**Blossom Street Parking Garage East Steel Stair Replacement
Project Number FP00000215**

Addendum Number Three

Date: January 11, 2019

Alternative Stair Replacement
Blossom Garage East Stair Replacement
Prepared For:
University of South Carolina, Columbia, SC

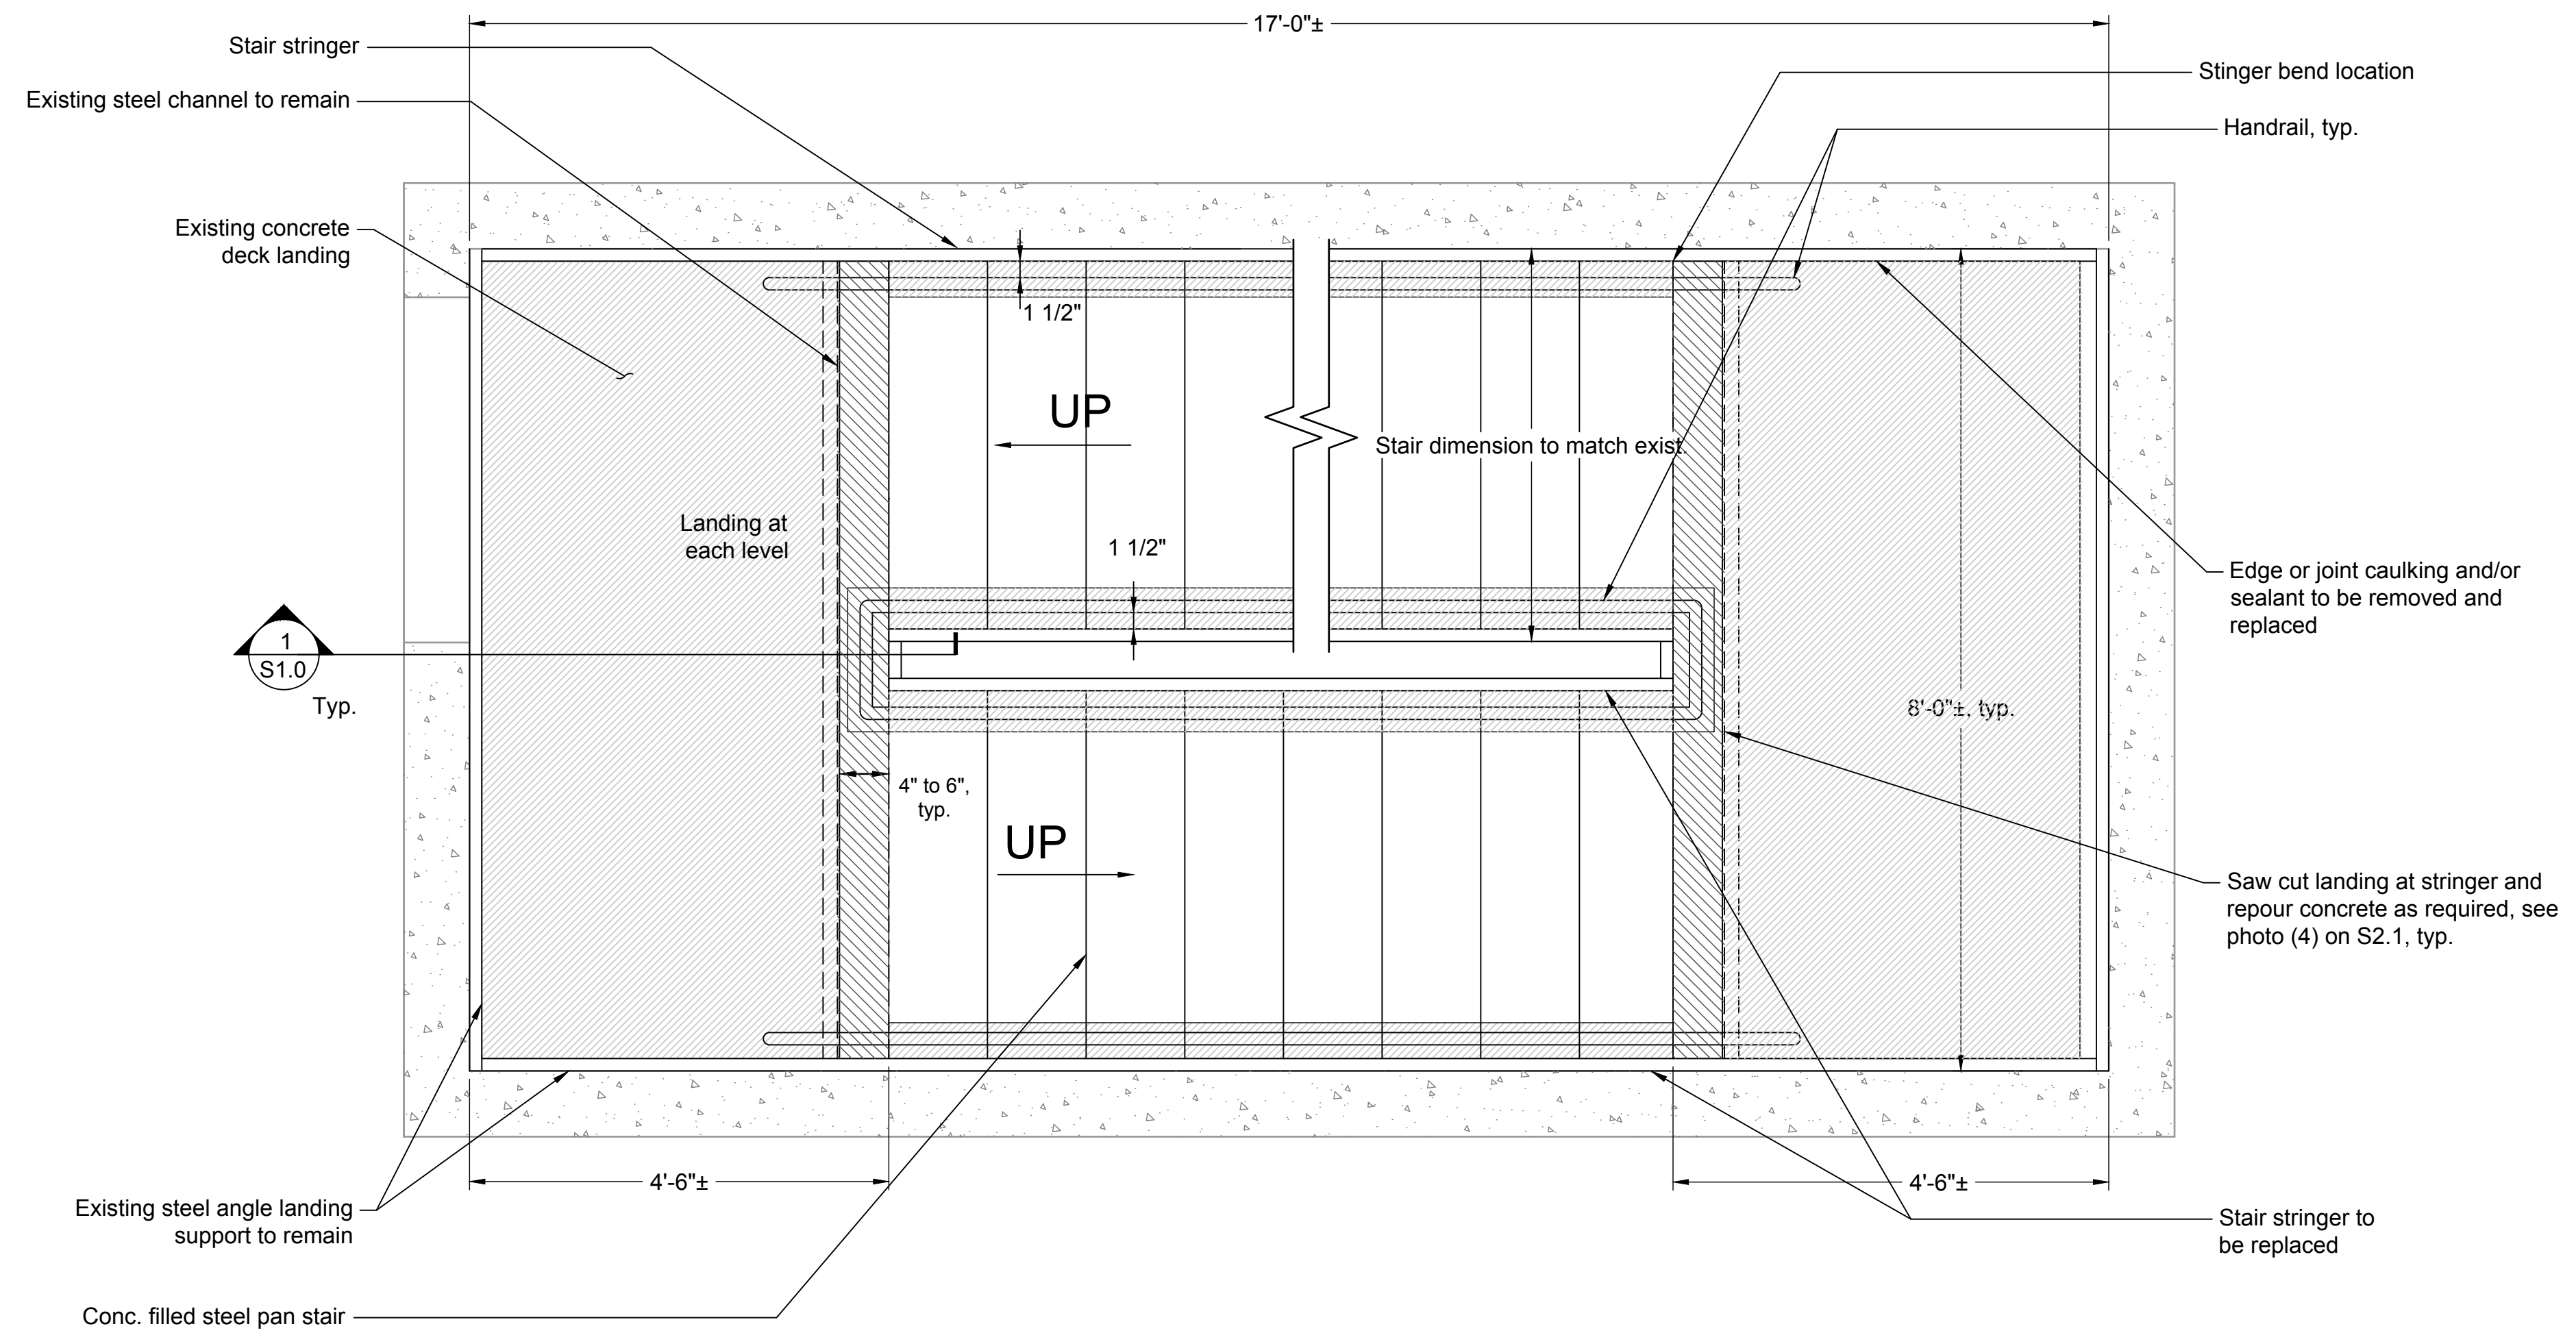
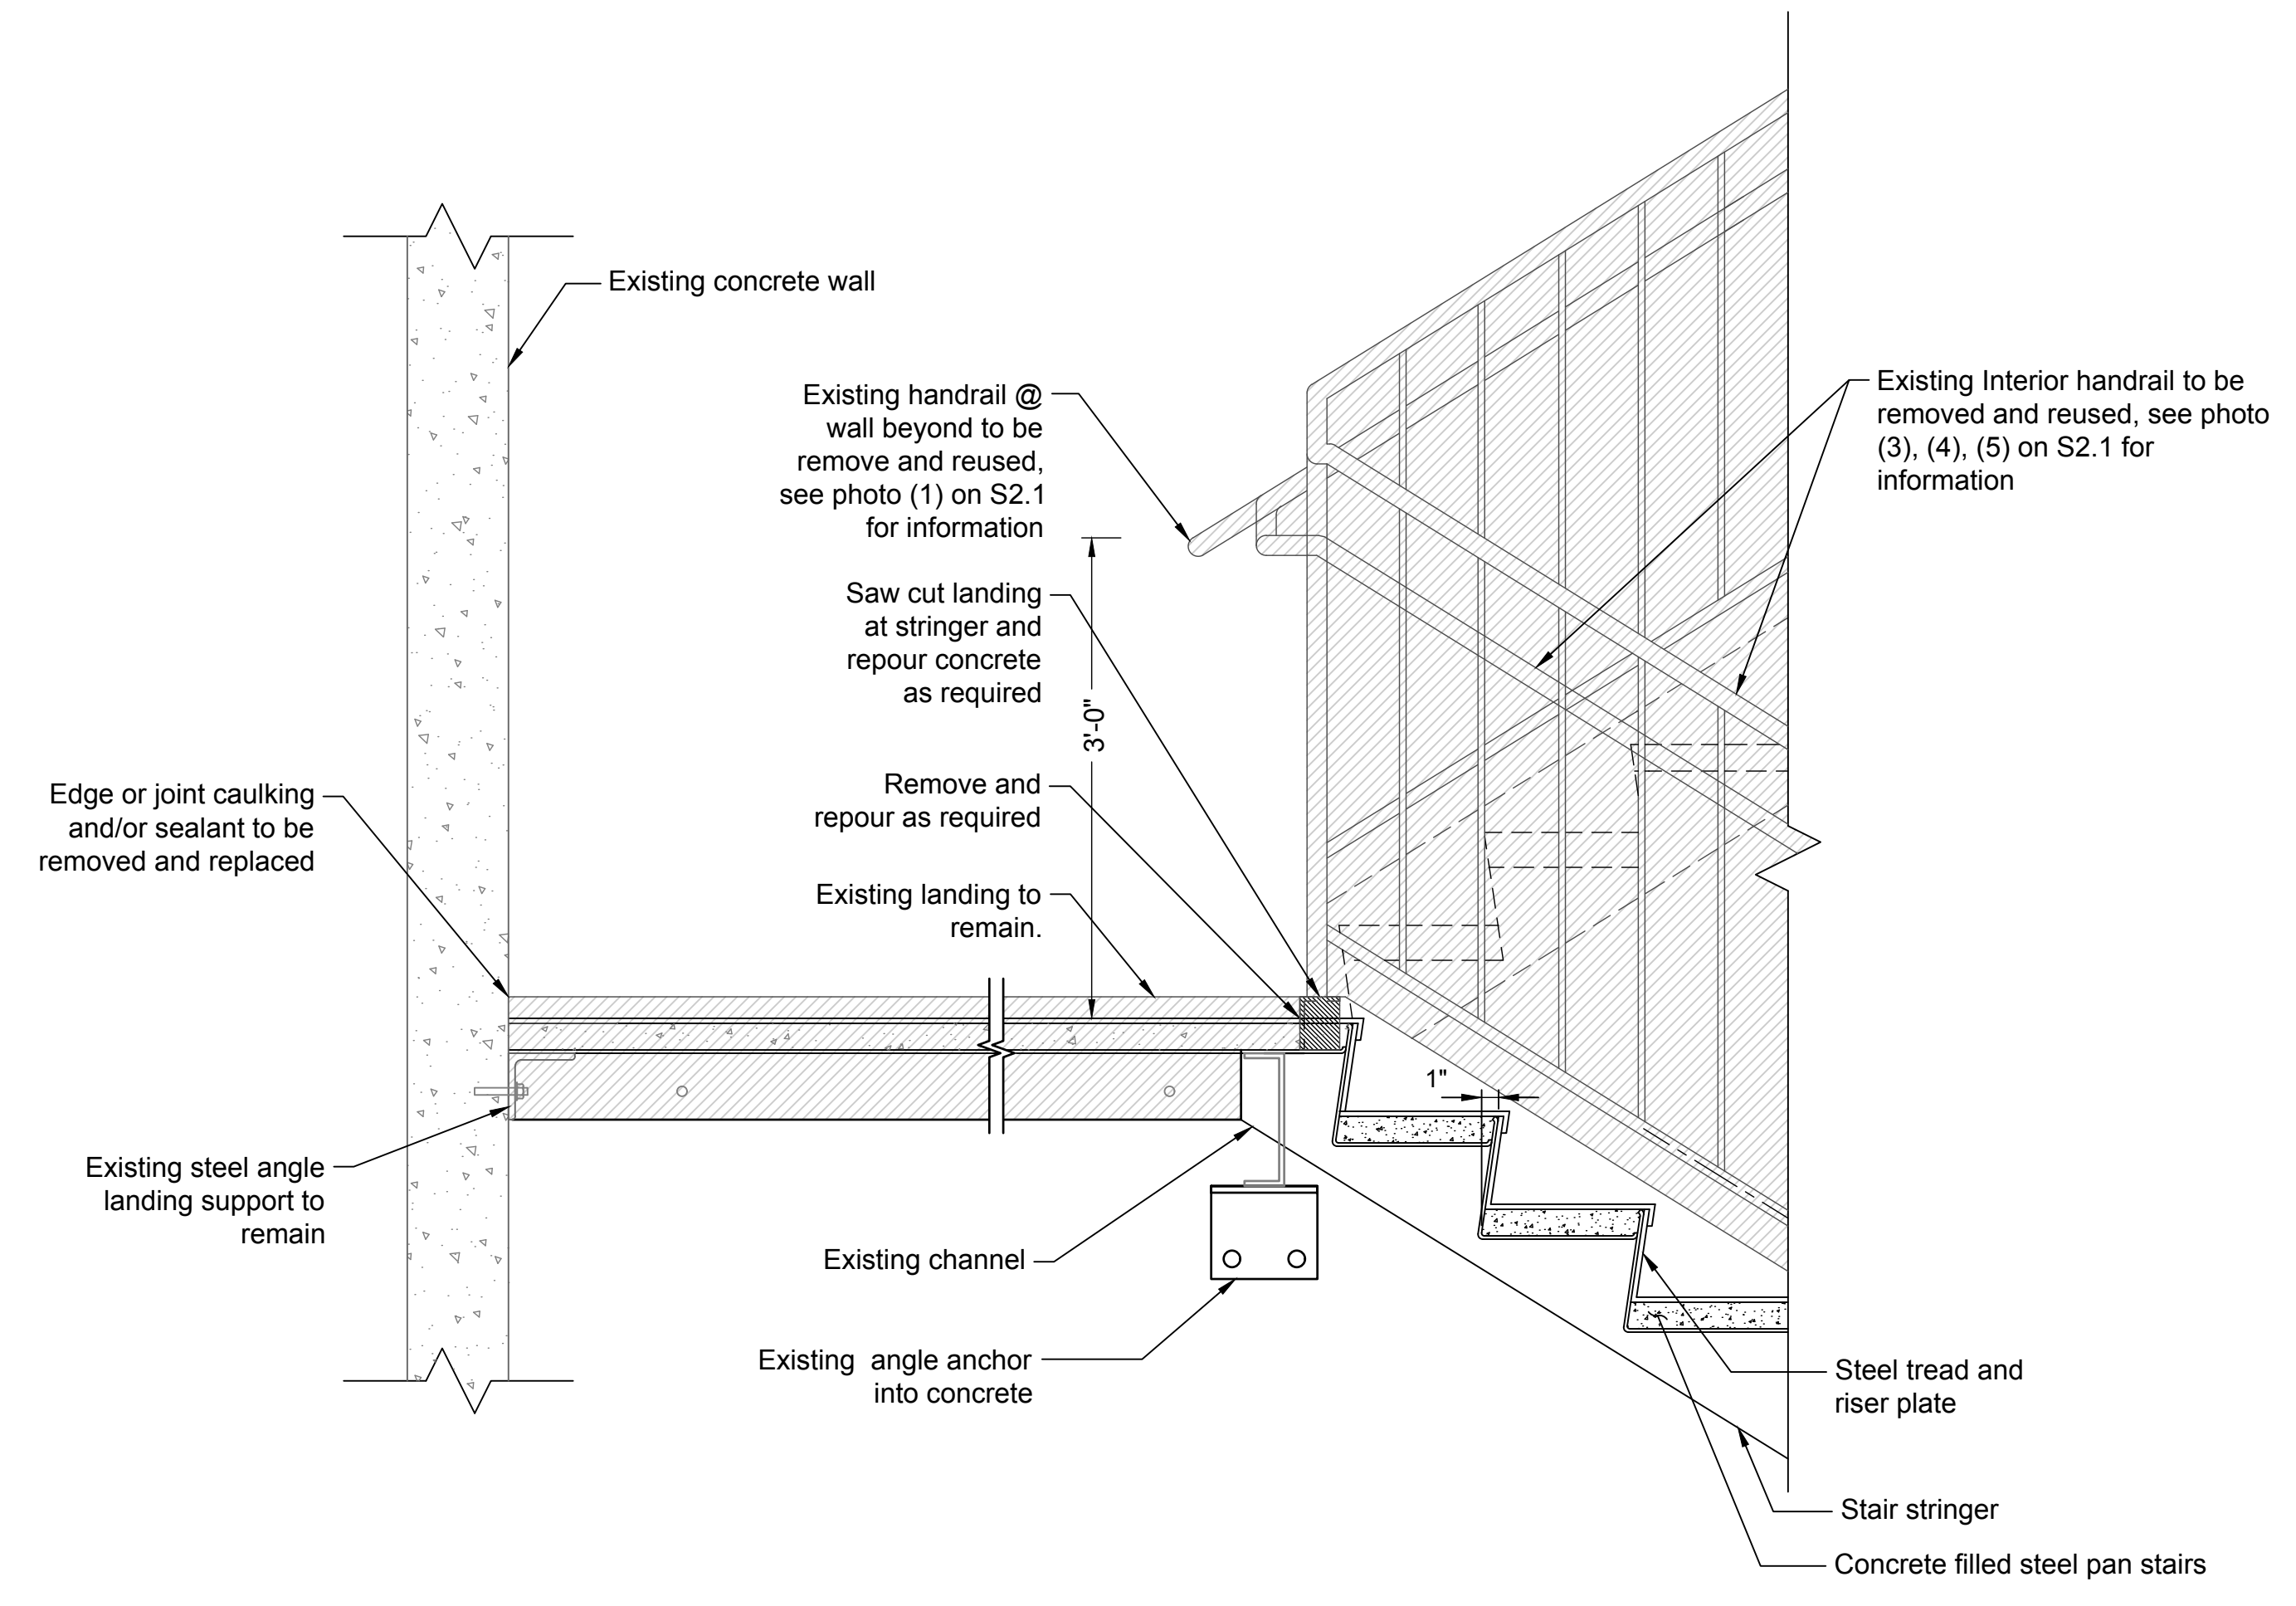
Denotes existing landing to remain and temporarily remove and reinstall existing railing and stairs once replaced. G.C. shall clean existing landing and railing and reapply paint after cleaning. Contractor shall submit paint color for owner's approval.

G.C. shall remove all temporary wood reinforcement shoring, see photo (1) and (2) on S2.1. Photos are for informational purposes only. Total quantities shall be evaluated by the contractor.
